Letter number MFN-09-690
November 5, 2009

Global Laser Enrichment
Docket Number 70-7016

SUBJECT: GE-HITACHI GLOBAL LASER ENRICHMENT RESPONSE TO REQUEST FOR
ADDITIONAL INFORMATION RELATED TO NRC REVIEW OF GLE
ENVIRONMENTAL REPORT

GLE Response to Environmental RAIs

Figure 4.5(E): Age and Condition of Biotic Communities Dominated by Pine

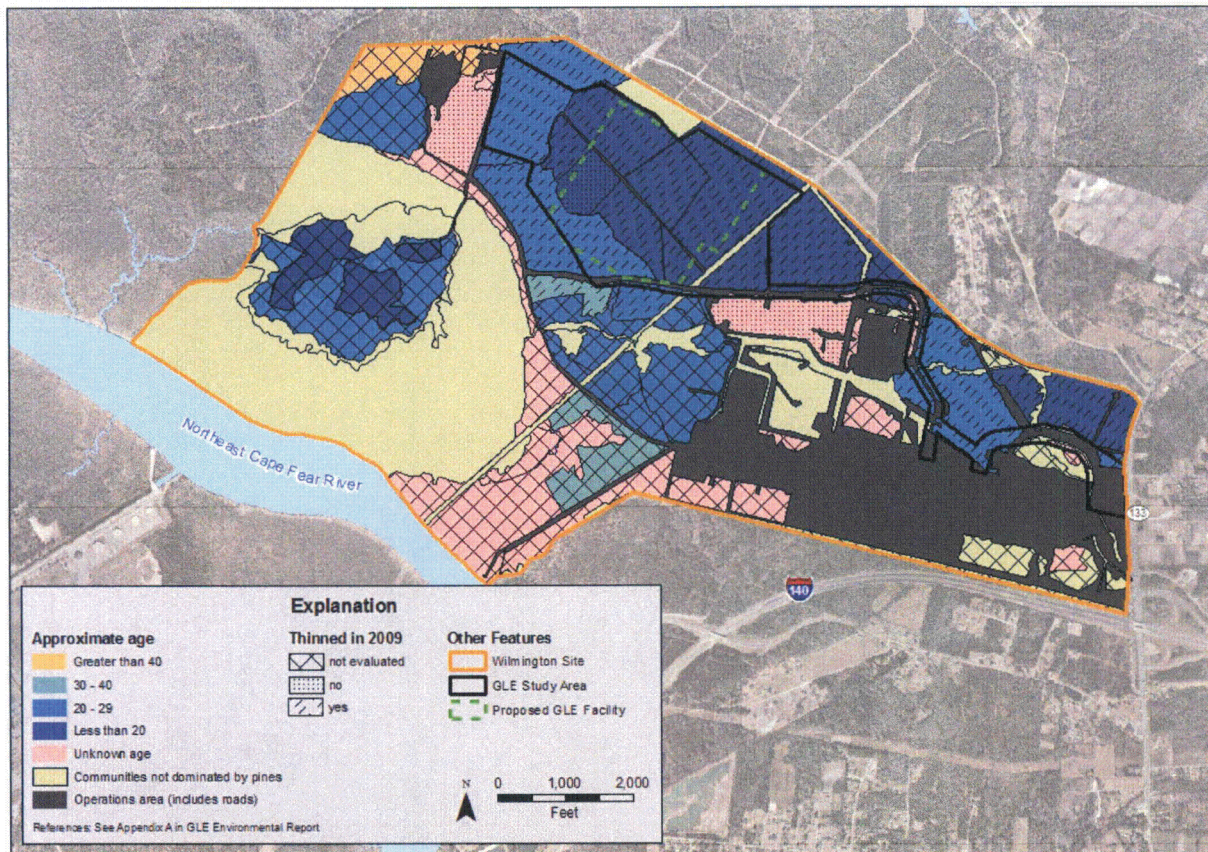
- E. Provide the most recent dates and areas where logging has occurred in the area proposed for the GLE facility. Also, provide whatever similar summary data is available for logging on the Wilmington site since 1980 (approximately). This information is needed to support conclusions about the suitability of the site for red-cockaded woodpecker habitat.

Figure 4.5(E) illustrates the age of the forest communities based on the 2009 GE Forest Management Plan; however, this scale is not at a fine enough resolution to identify areas that were planted versus naturally regenerated. The area within or adjacent to the GLE Study Area was observed in October 2009 to verify which areas had received thinning treatments. In addition to being thinned, some areas received additional reduction of sub-canopy vegetation within the rows.

Figure 4.5(F). Planned Projects on the Wilmington Site.

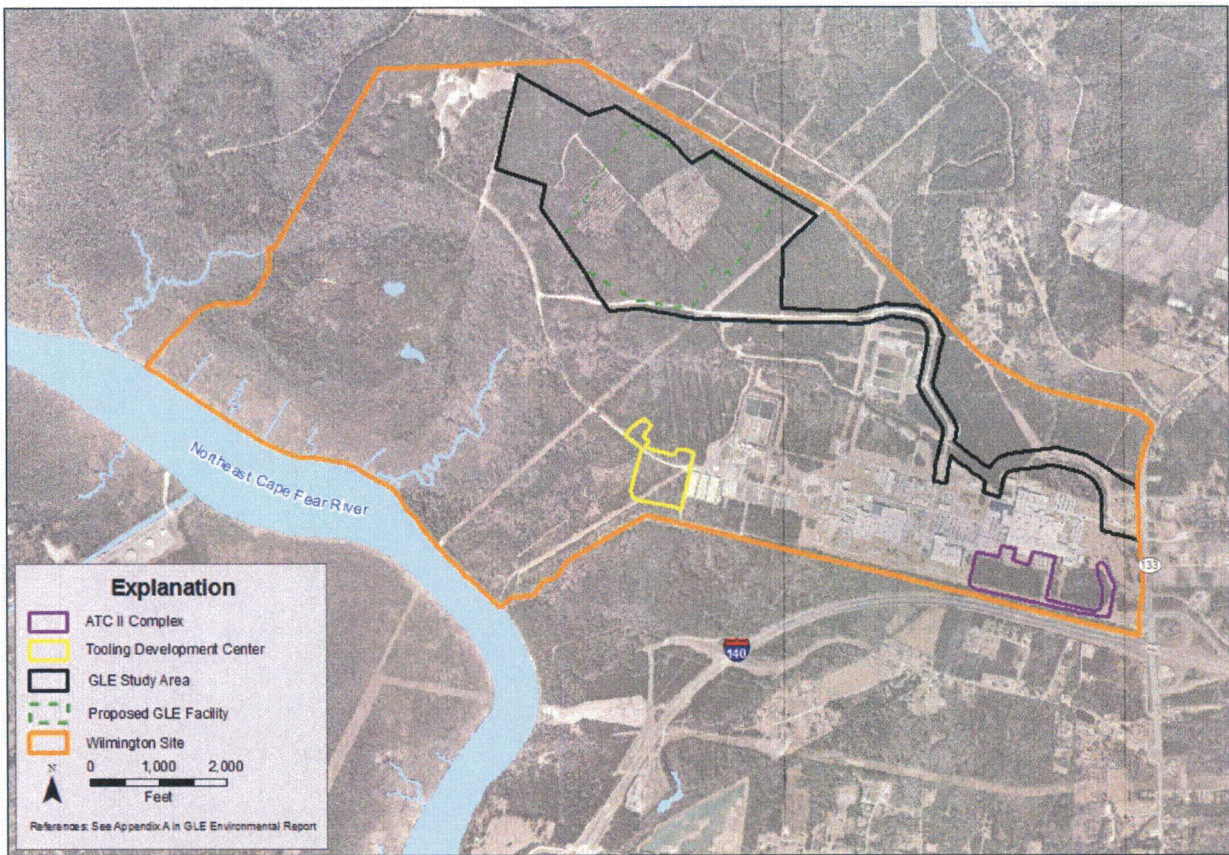
- F. Provide a figure similar to ER Figure 1-2 that shows the “30-acre” area outlines for the proposed ATC II complex and the Tooling and Development Center. This information is needed for the cumulative impacts analysis.

Figure 4.5(F) illustrates the location of the proposed ATC II Complex and the Tooling Development Center on the Wilmington Site. The ATC II complex in the southeastern portion of the Eastern Site Sector near the South Gate has impacted approximately 20.66 acres (8.36 ha) consisting of 11.30 ac (4.57 ha) of Pine Forest and less than 0.01 acres (0.01 ha) Pine-Hardwood Forest.

The Tooling and Development Center would impact approximately 16.31 acres (6.60 ha), consisting of 0.28 ac (0.13 ha) of Pine Forest, 7.27 ac (2.94 ha) of Pine-Hardwood Forest, and 6.45 ac (2.61 ha) of Pine Plantation habitat in the western portion of the Eastern Site Sector. The cumulative effect from both of these projects would be the loss of approximately 24.3 acres (9.8 ha) of habitat in conjunction with the loss of approximately 177 acres (72 ha) of habitat from the Proposed Action. Total loss of available habitat would be approximately 202 acres (82 ha), comprising 16% of the forest habitat currently on the Wilmington Site.
